劣化損傷の評価と対応

(2016年11月30日追補)

この追補は、2014年7月1日に改訂された“劣化損傷の評価と対応”2014年版の追補である。したがって、今後、**JPI-8R-12-2014**とは、この追補も含むものとする。

図 3.1.11 ネルソン線図 (API RP 941 第 8 版)

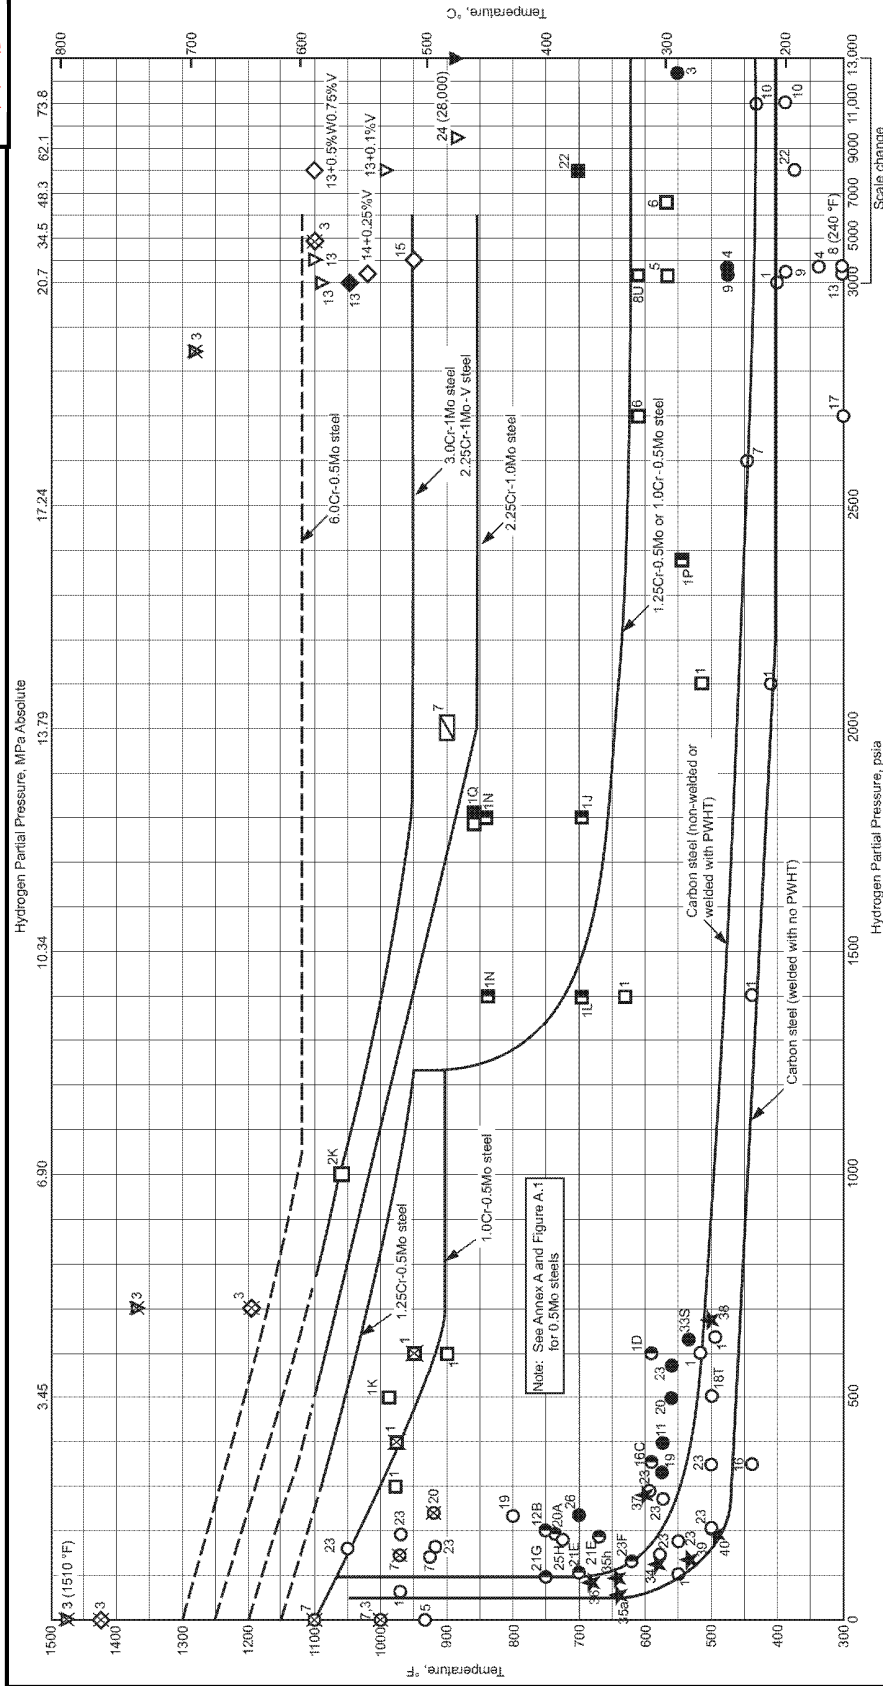
3.1.2 水素侵食の発生範囲 水素侵食の発生限界は **API Publication 941** (第 5 版以降 **API RP 941**) のネルソン線図 (図 3.1.11) に示されている。しかし、このネルソン線図は、1949 年の発表以降、設備の使用実績に基づいてたびたび改訂されており、1990 年の第 4 版では、C-0.5Mo 鋼の損傷事例にもとづいて、同鋼種の曲線が削除された。また、最新版 (第 7 版、(2008 年) では、1.25Cr-0.5Mo 鋼の安全域における損傷事例が紹介されており、Cr 含有量はいずれも同鋼種の下限值に近いものであったが、同鋼種の使用に対して注意喚起されている。さらに、**第 8 版 (2016 年) では、溶接後熱処理を実施していない炭素鋼溶接部に関して、ネルソン線図の安全域における損傷事例が数件報告されたことを受けて、従来の炭素鋼の曲線の下に新たに溶接後熱処理なしの炭素鋼溶接部の限界線が追加された**が最近いくつか報告されており、~~API RP 941 委員会は高温水素サービスで使用されている溶接後熱処理未実施の炭素鋼機器と配管に対して、注意喚起している~~^[54, 55]。

図の修正
